ADDENDUM NO. 01

November 7, 2025

To Drawings and Specifications dated October 24, 2025

Reynolds Elementary School Maintenance Improvements
Spring Independent School District

2 PLUMBING FLOOR PLAN - BOYS RR 306 & GIRLS RR 307
Scale: N.T.S.

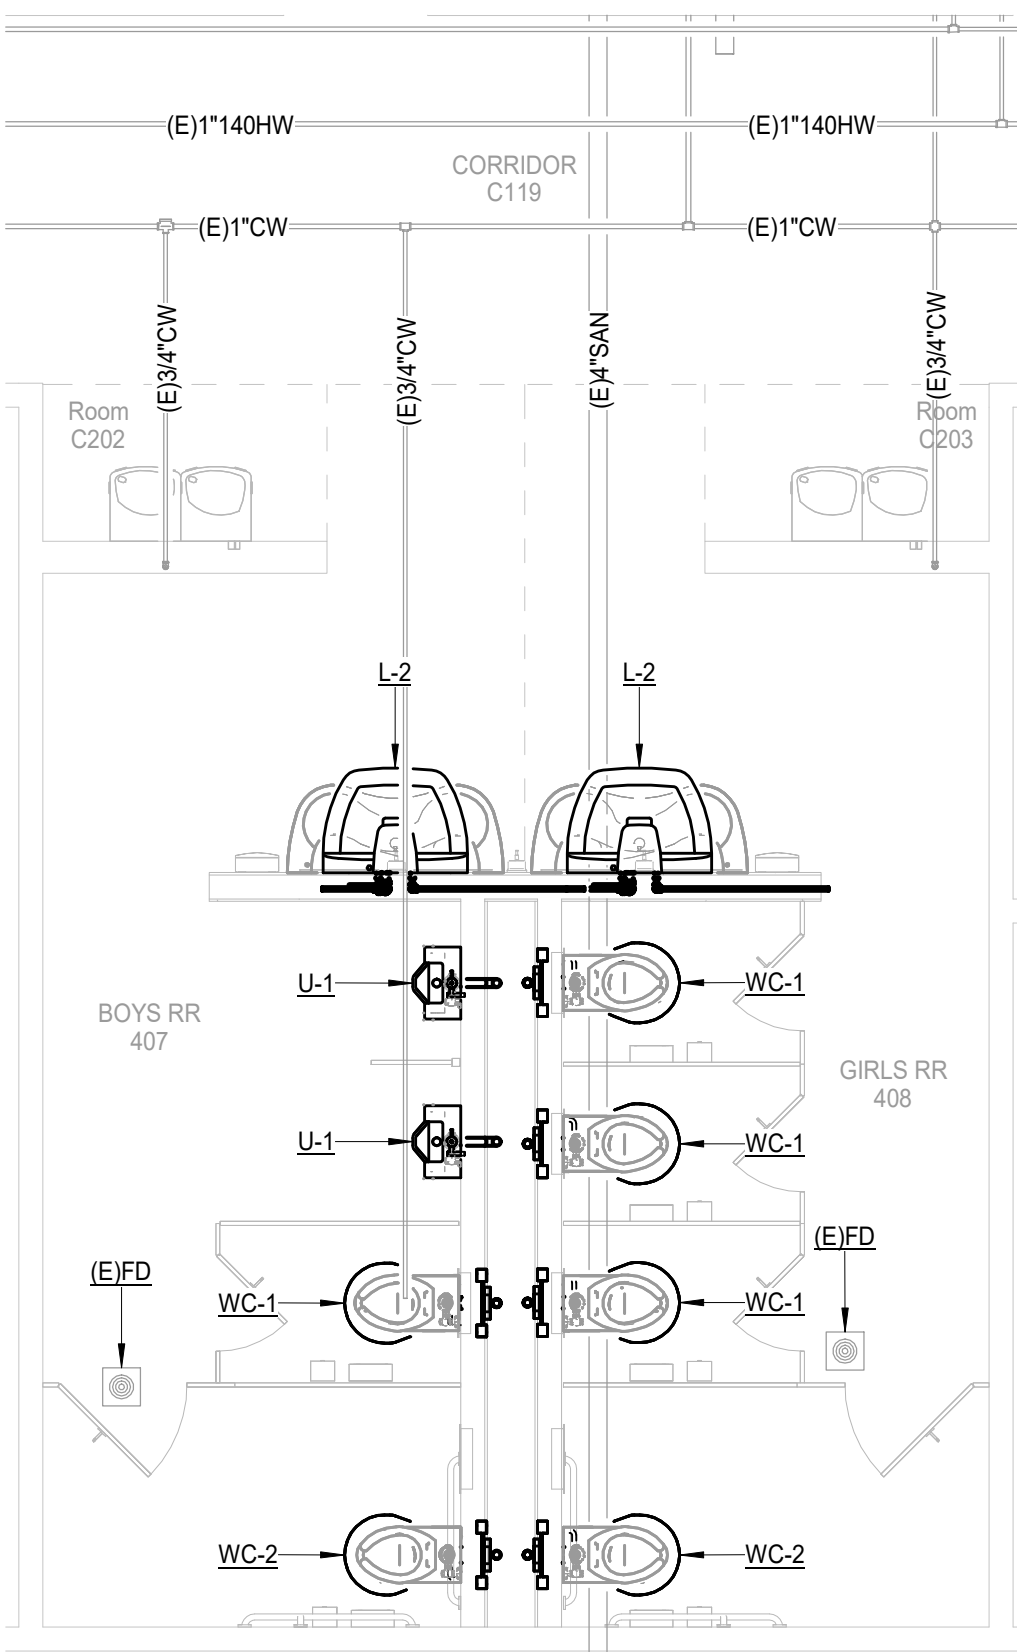
- Item No. 34 Sheet P-4.01, Plumbing Plans – Enlarged
B. Discard and replace with enclosed.
a. Revise Keynote #1 to state, “EXISTING LAVATORY FIXTURE AND CARRIER TO BE REMOVED. REMOVE CW, HW, SANITARY AND VENT BACK TO POINT INDICATED.”

b. Revise Keynote #2 to state, “EXISTING WATER CLOSET FIXTURE AND CARRIER TO BE REMOVED. REMOVE CW, SANITARY AND VENT BACK TO POINT INDICATED.”
c. Revise Keynote #3 to state, “EXISTING URINAL FIXTURE AND CARRIER TO BE REMOVED. REMOVE SANITARY, CW AND VENT BACK TO POINT INDICATED.”

- Item No. 35 Sheet P-4.01, Plumbing Plans – Enlarged
B. Discard and replace with enclosed.
a. Revise Keynote #1 to state, “EXISTING LAVATORY FIXTURE AND CARRIER TO BE REMOVED. REMOVE CW, HW, SANITARY AND VENT BACK TO POINT INDICATED.”

b. Revise Keynote #2 to state, “EXISTING WATER CLOSET FIXTURE AND CARRIER TO BE REMOVED. REMOVE CW, SANITARY AND VENT BACK TO POINT INDICATED.”
c. Revise Keynote #3 to state, “EXISTING URINAL FIXTURE AND CARRIER TO BE REMOVED. REMOVE SANITARY, CW AND VENT BACK TO POINT INDICATED.”

- Item No. 36 Sheet P-4.01, Plumbing Plans – Enlarged
A. Discard and replace with enclosed.
a. Revise Keynote #4 to state, “EXISTING LAVATORY FIXTURE AND CARRIER TO BE REMOVED. REMOVE CW, HW, SANITARY AND VENT BACK TO POINT INDICATED.”

b. Revise Keynote #5 to state, “EXISTING WATER CLOSET FIXTURE AND CARRIER TO BE REMOVED. REMOVE CW, SANITARY AND VENT BACK TO POINT INDICATED.”
- Item No. 37 Sheet P-6.01, Plumbing Schedules

1 TECHNOLOGY FLOOR PLAN
Scale: 1/16" = 1'-0"

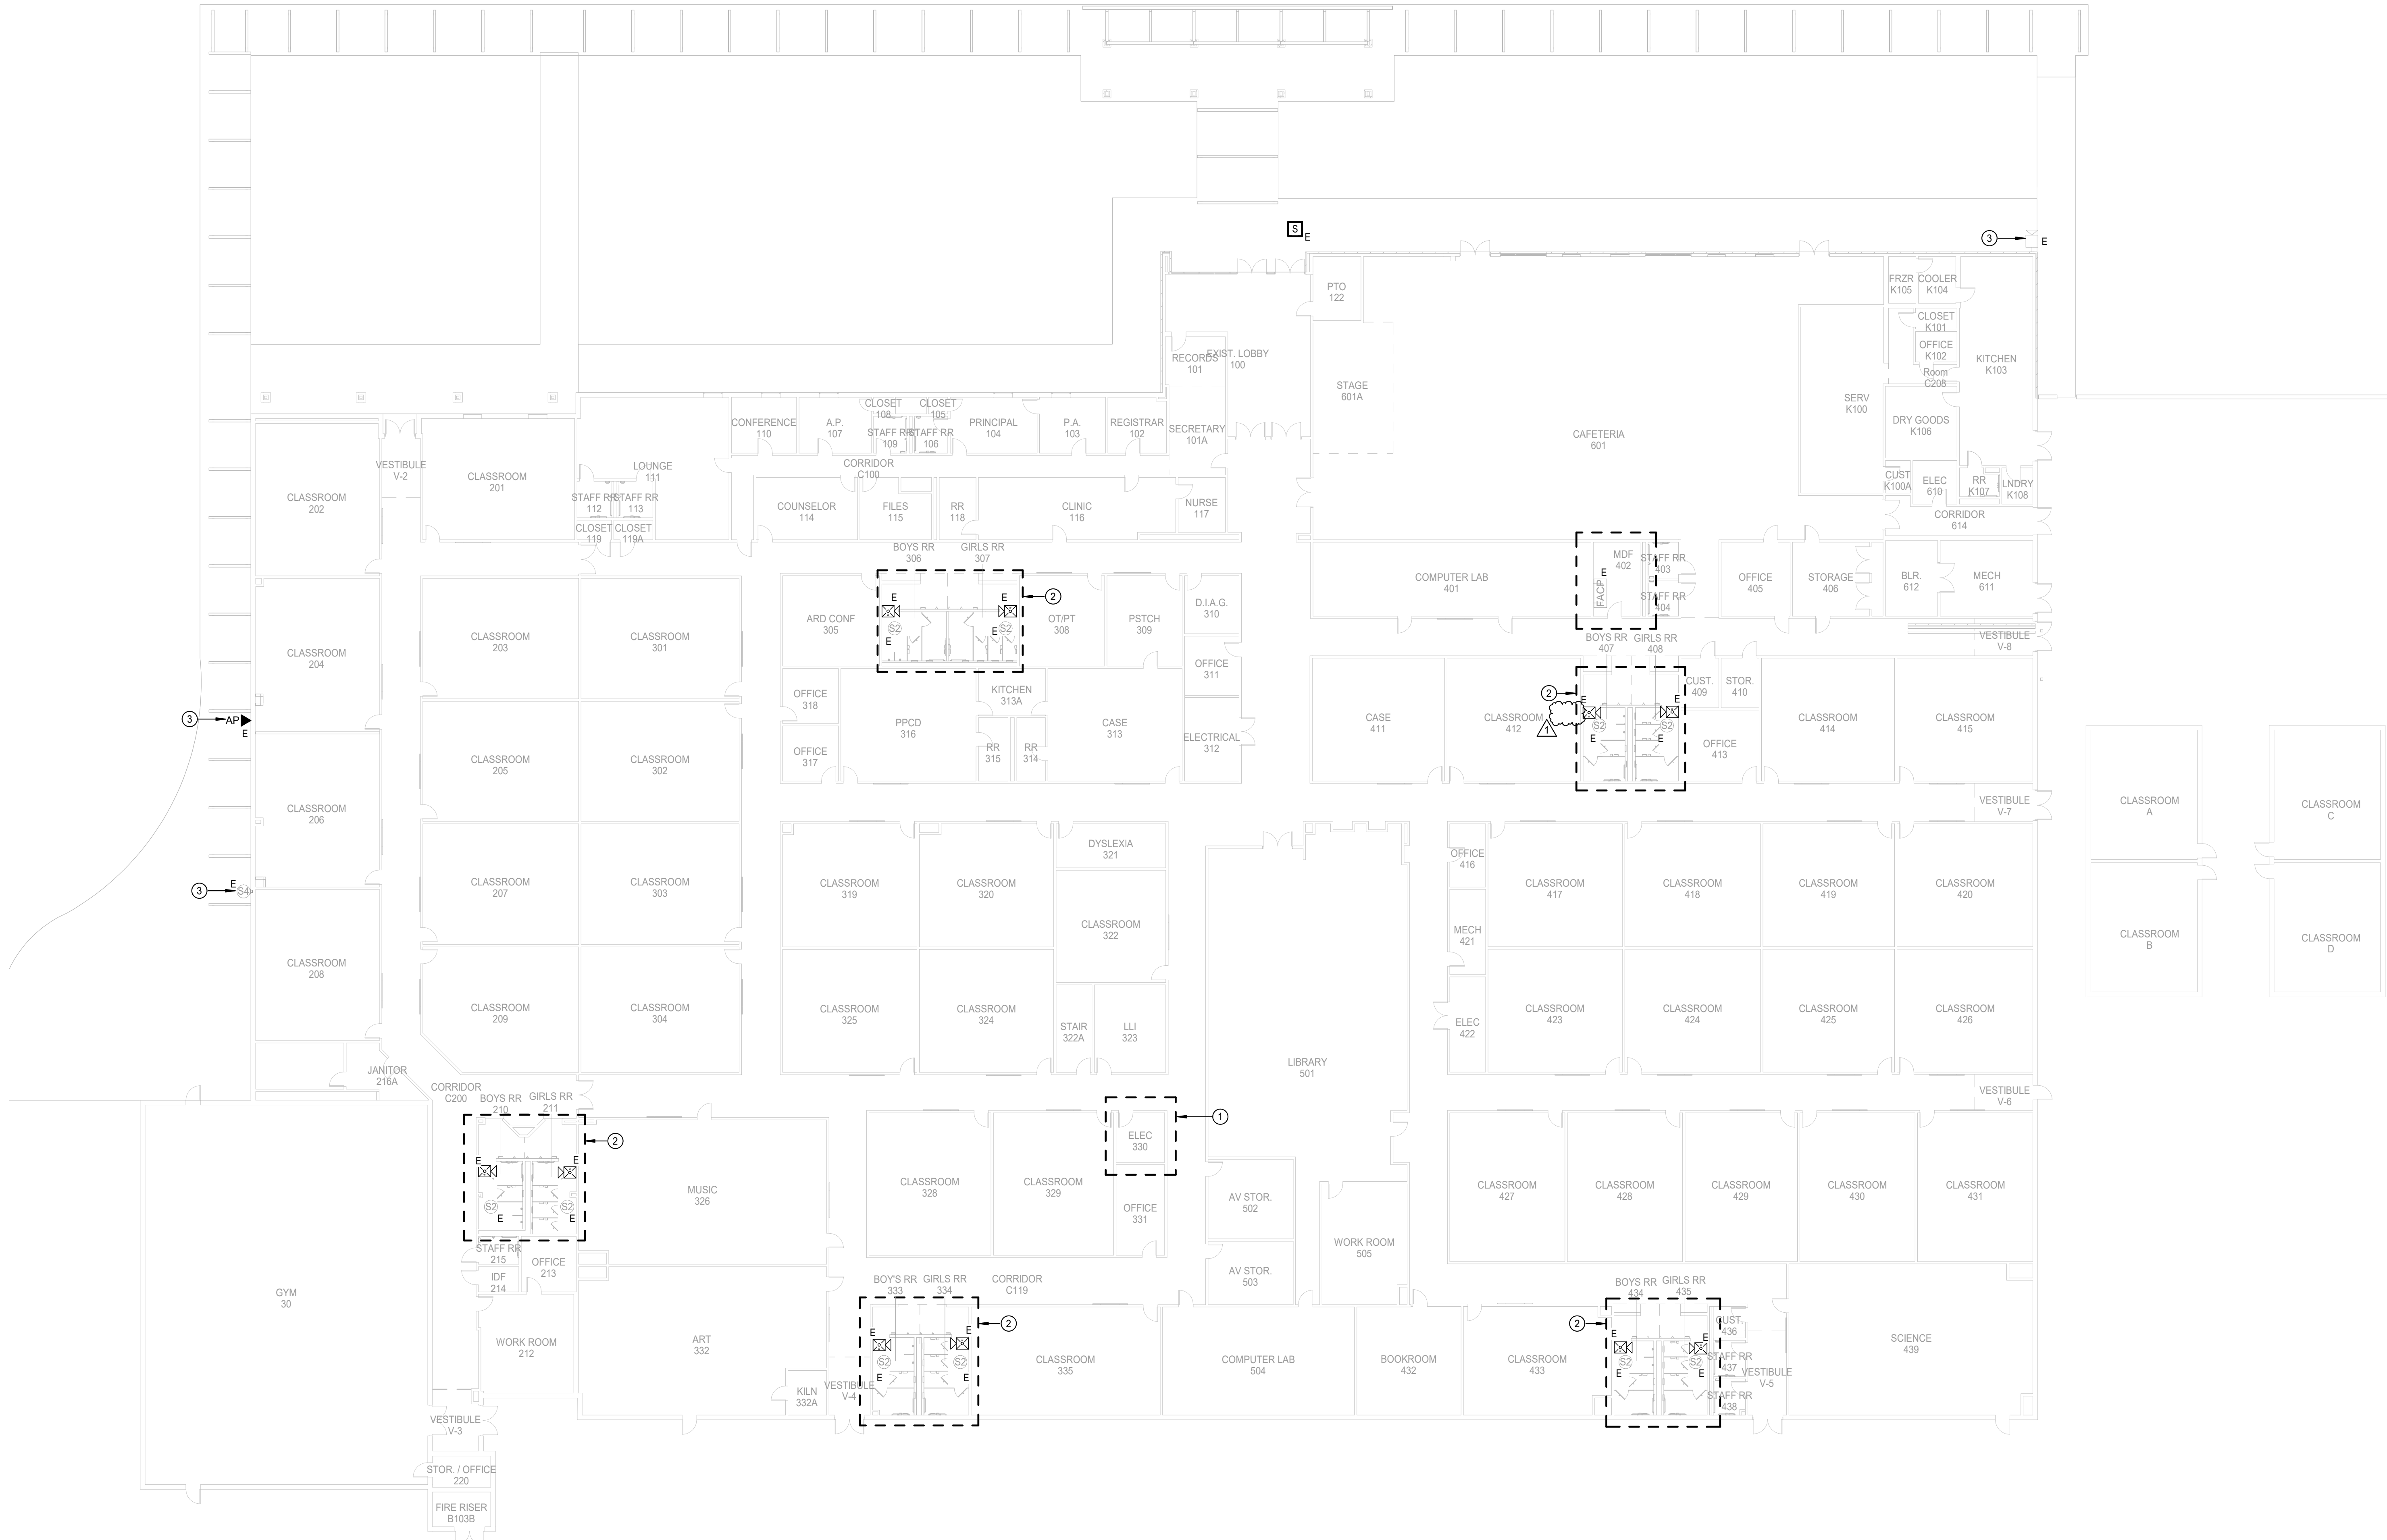
- Item No. 38 Sheet T2.01, Technology Plans
A. Remove Technology Plan Key Note #4.
B. Update Fire Alarm Legend
